SNECKER AND ASSOCIATES
MARSHALL RANCH COMMERCIAL

P.O.A.D.P.

Re: Marshall Ranch

POADP # 624-A
(Amending)

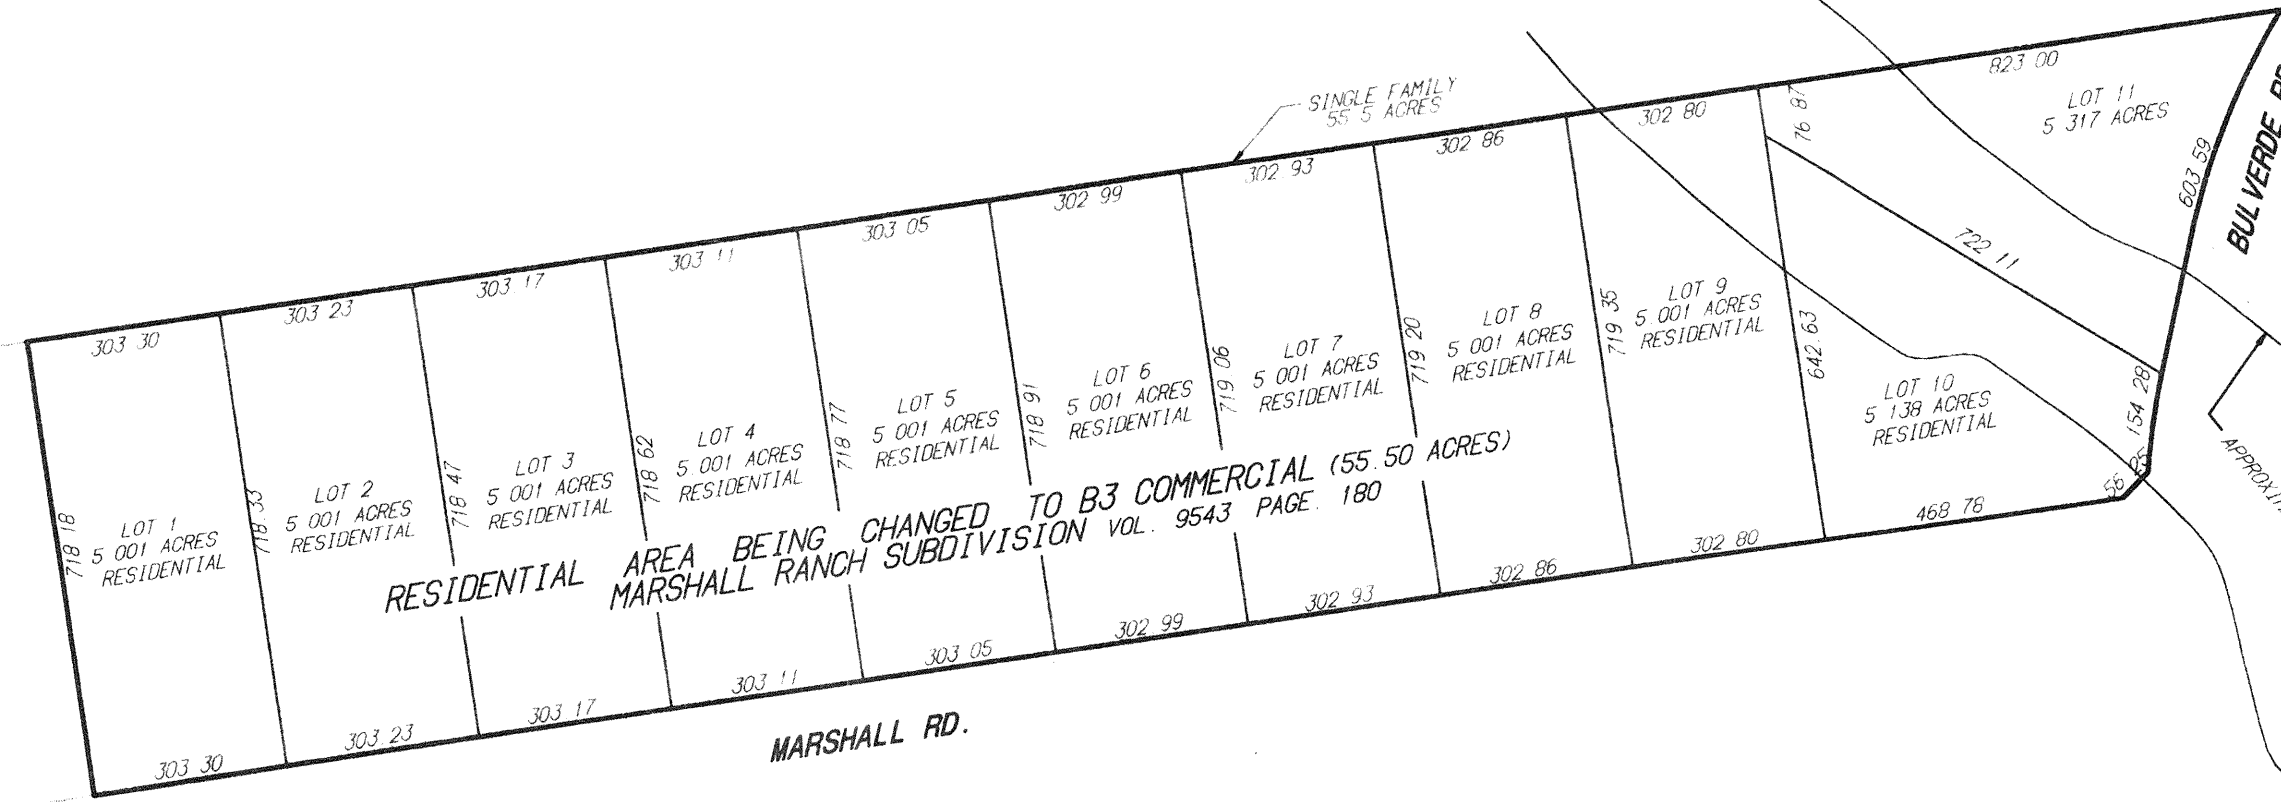
Has a flood study been completed to establish BFEs -?
OSSE
① Is property to be served by sanitary sewer?

P.O.A.D.P.

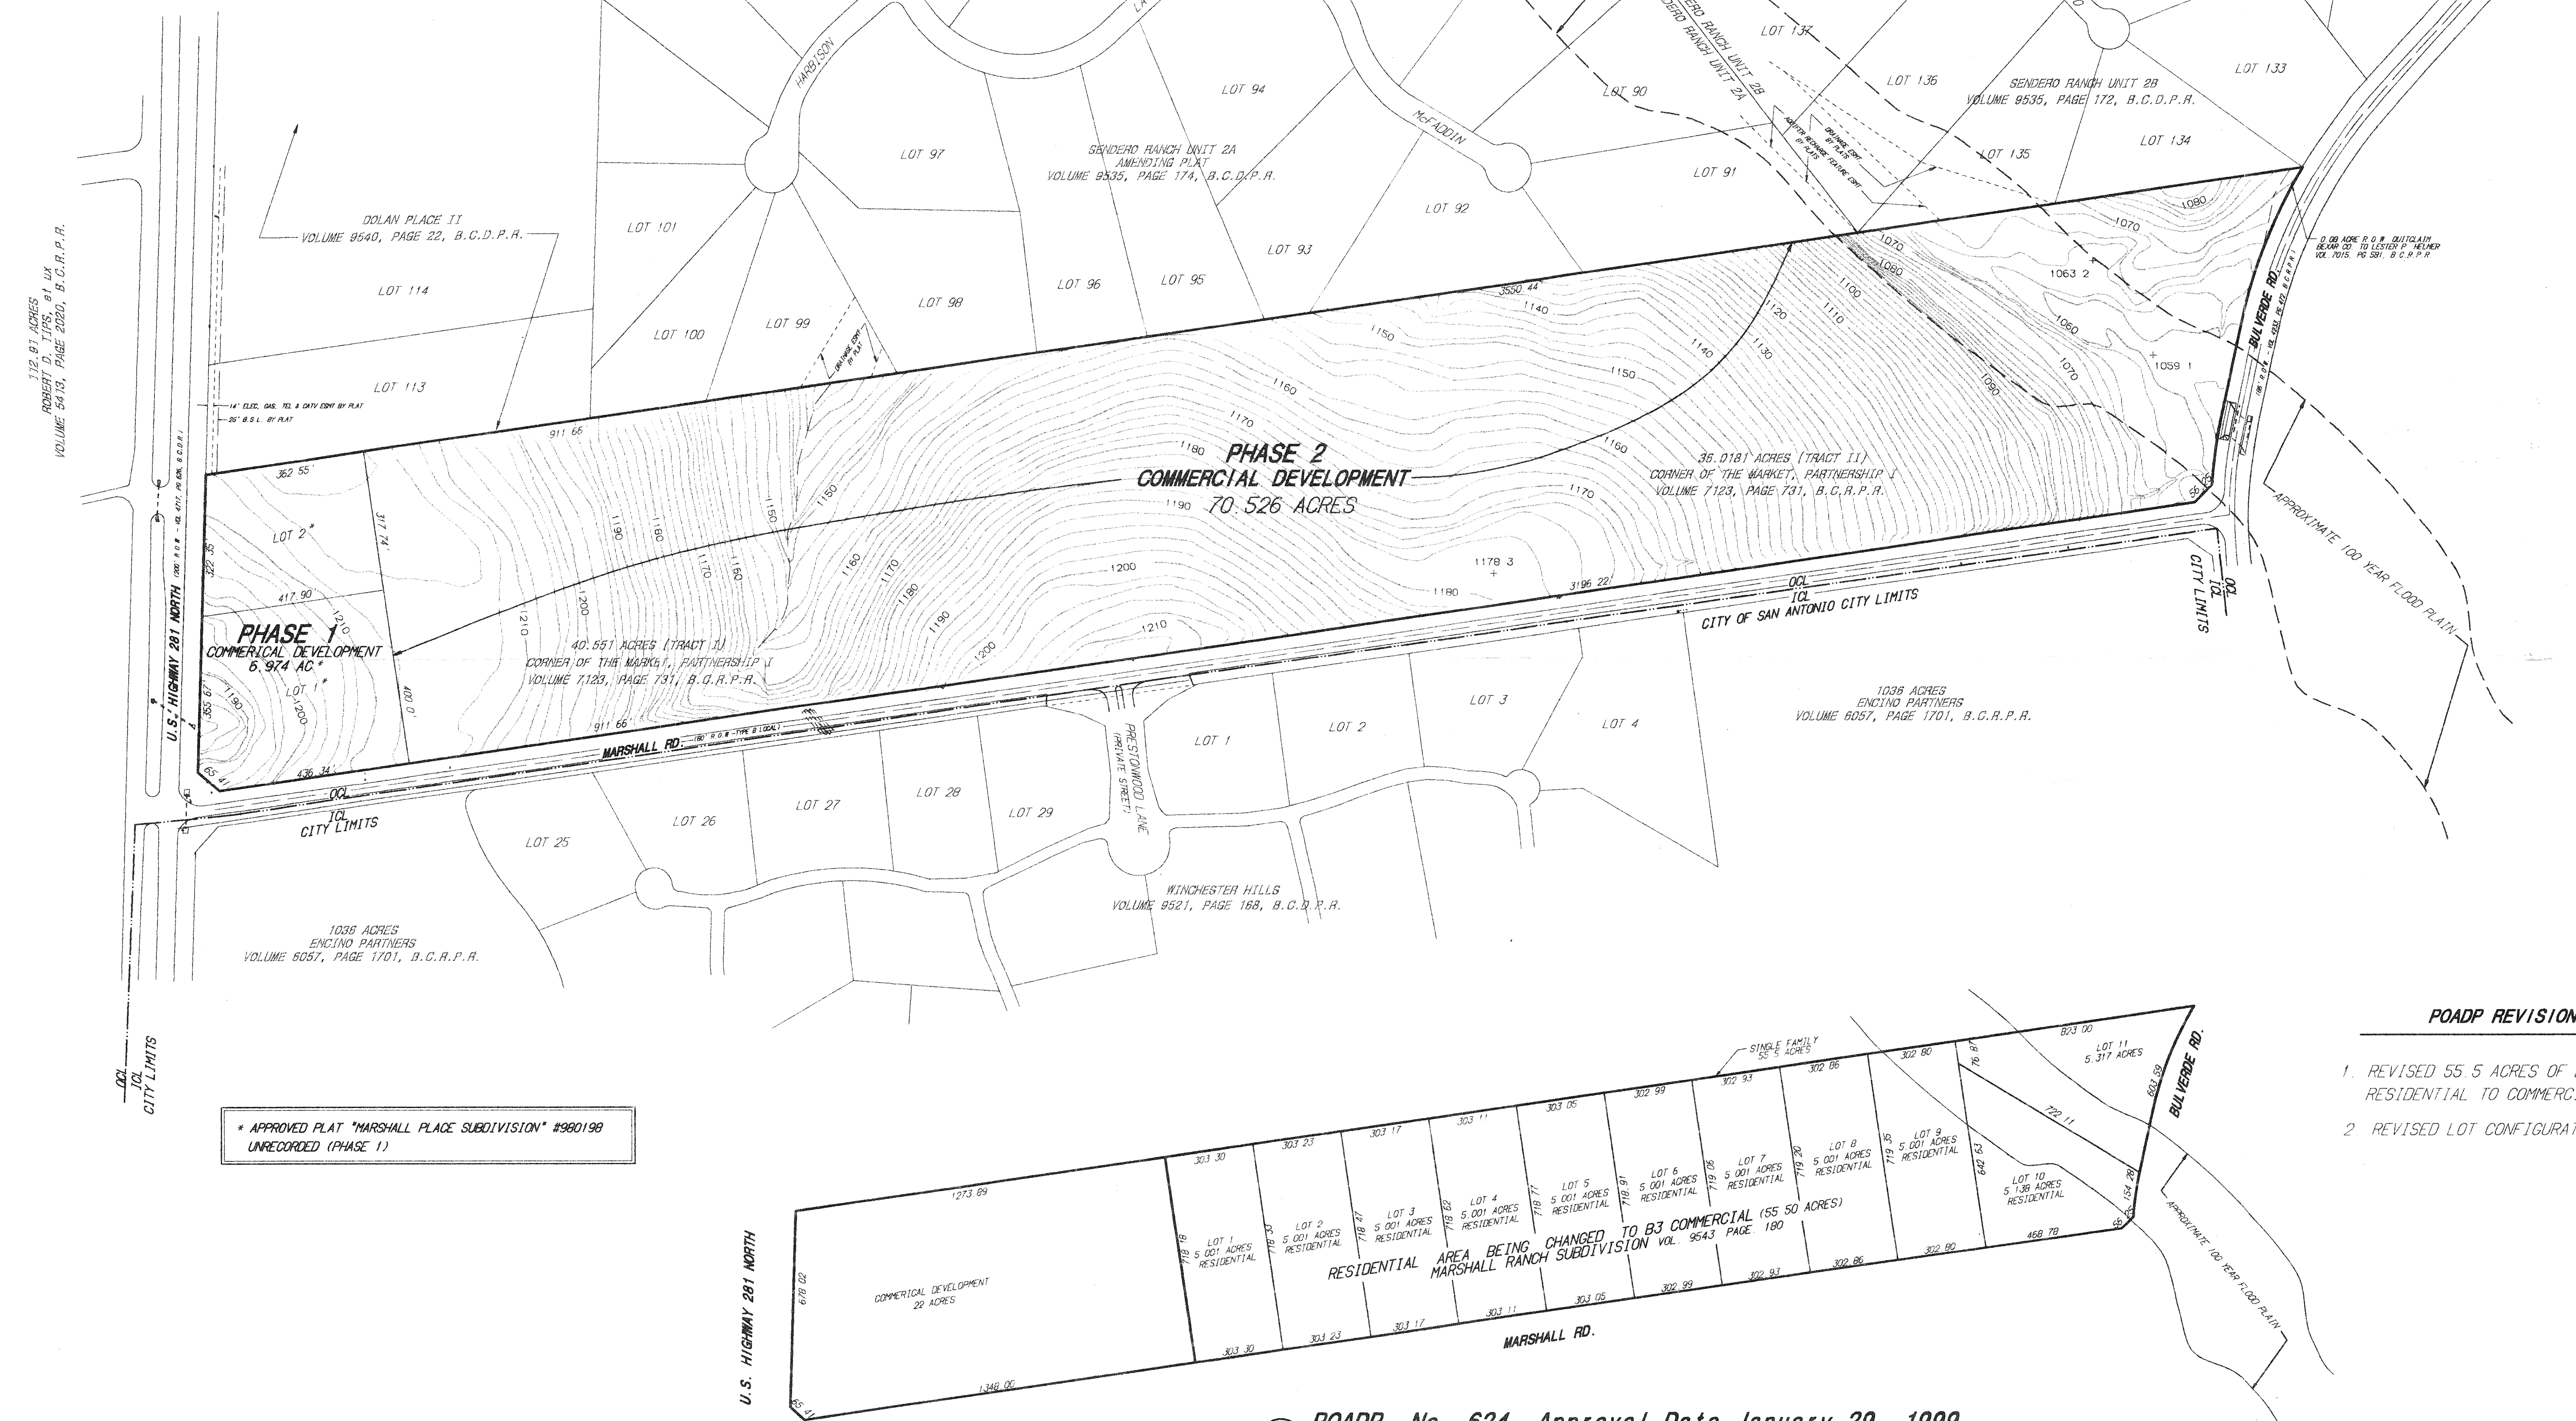
The City Staff Development Review Committee has reviewed Marshall Ranch Subdivision Preliminary Overall Area Development Plan # 6624-A. Please find enclosed a signed copy for your files. Although your plan was accepted, please note the following:

- Based on the topography, a Flood Plain Study and drainage review will probably be required during the platting process. Bexar County Public Works may require base flood elevations at the plat level.

- Access and R.O.W. issues along State facilities will need to be resolved with the Texas Department of Transportation (TXDOT). For information about these requirements you can contact TXDOT at 615-5814.

- Section 35-4113(d) of the Unified Development Code (UDC) states that "Additional right-of-ways beyond that specified by the major thoroughfare plan may be required for major thoroughfares and or their intersections in order to meet State Department of Highways and Public Transportation requirements. The total right-of-way will generally not exceed one hundred twenty (120) feet. The highway department has indicated that they will need one hundred fifty (150) feet along US 281.

LAND TITLE SURVEY OF 77.464 ACRES OF LAND OUT OF THE WILLIAM BRISBIN SURVEY NO. 89 1/2, ABSTRACT NO. 54, COUNTY BLOCK 4900, BEXAR COUNTY, TEXAS.

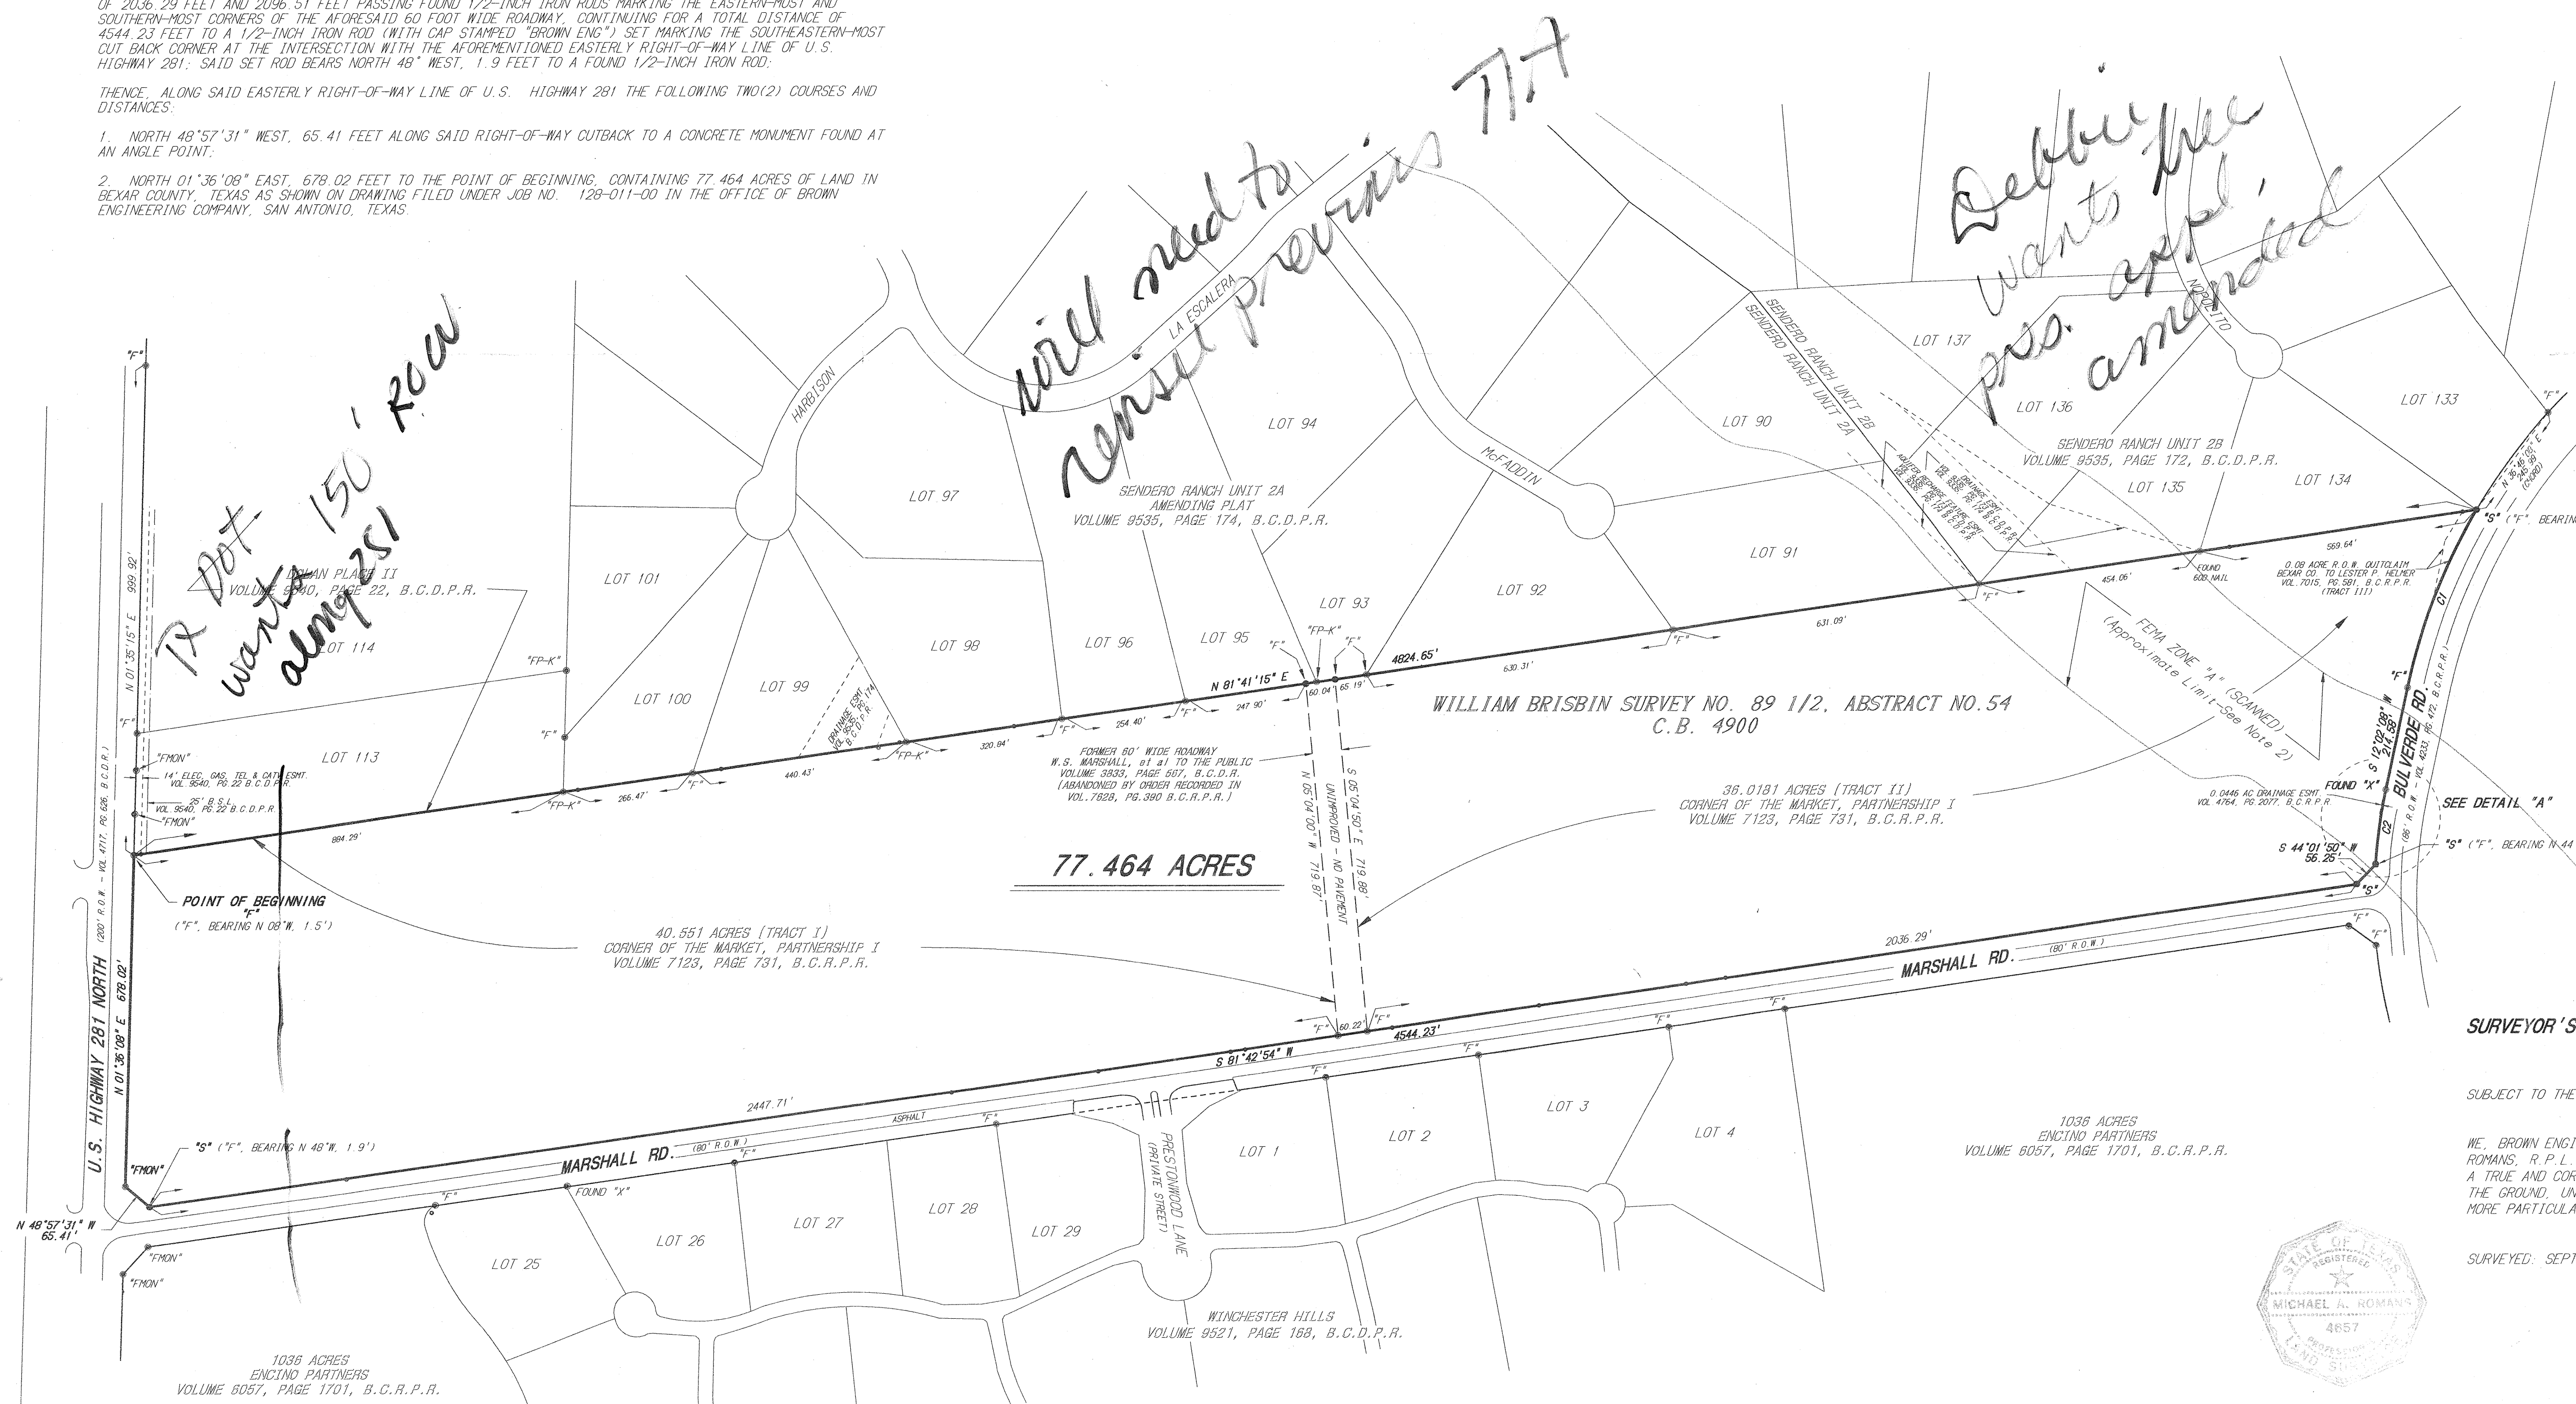
will need to revise previous 77.7

Setting free wants pss. amended

TX DOT wants along 281 ROW
